## **LABRADOR RUN SUBDIVISION**

This is a request for a one-year extension of a previously approved 427 Lots / 229.3± acre subdivision. The subdivision is located on the West terminus of Belmont Park Drive, extending to the South side of Ben Hamilton Road at the South terminus of Mose Circle (private street).

# DETAIL SITE PLAN

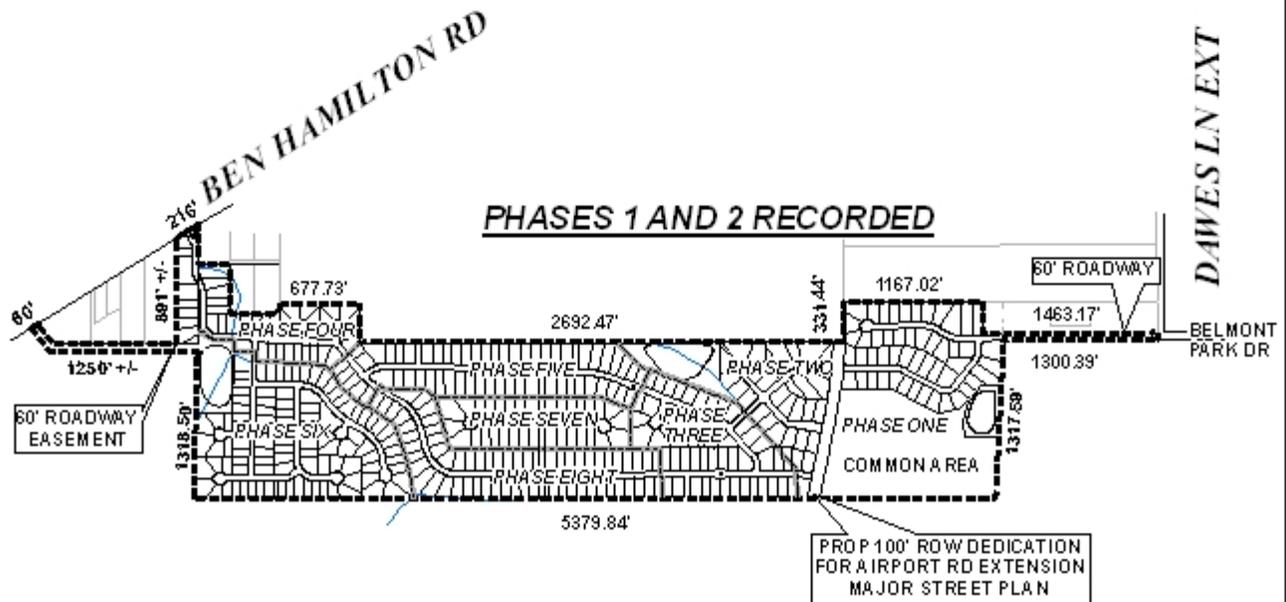
- 1) provision of street-stubs to the land-locked parcel North of proposed lots 20-21 and 26-27 in Phase Four, and the land-locked parcel South of Phase Six, in compliance with Section V.B.1. of the Subdivision Regulations;

- 2) identification of all portions of the site to fully account for all acreage and the manner of site development, specifically the land near proposed lots 7, 187-190, and 390;

- 3) depiction of any existing drainage easements associated with previous subdivisions (Lot 1, Duncan Subdivision);
- 4) identification of the size of all lots in square feet, either via a table on the plat, or by the labeling of each lot, to ensure that each lot meets the minimum lot size identified in Section V.D.2. of the Subdivision Regulations;

- 5) depiction of the 25-foot minimum building setback line, in conformance with Section V.D.9. of the Subdivision Regulations;
- 6) identification and labeling of all common areas, including greenspaces, road medians, and detention areas, and placement of a note on the plat stating that maintenance of all common areas shall be the responsibility of the subdivision's property owners;

- 7) placement of a note on the plat stating that access to the 60-foot roadway easement on the West side of site is denied;
- 8) placement of a note on the final plat stating that any lots which are developed commercially and adjoin residentially developed property must provide a buffer, in compliance with Section V.A.7. of the Subdivision Regulations;

- 9) submission of certification to Urban Development by a licensed engineer that detention facilities are adequate to comply with City of Mobile volume and discharge rate standards prior to signing of the final plat; and

- 10) cul-de-sac rights-of-way and pavement diameters for Phases Three and higher to comply with Sections V.B.14. and V.B.15. of the Subdivision Regulations.
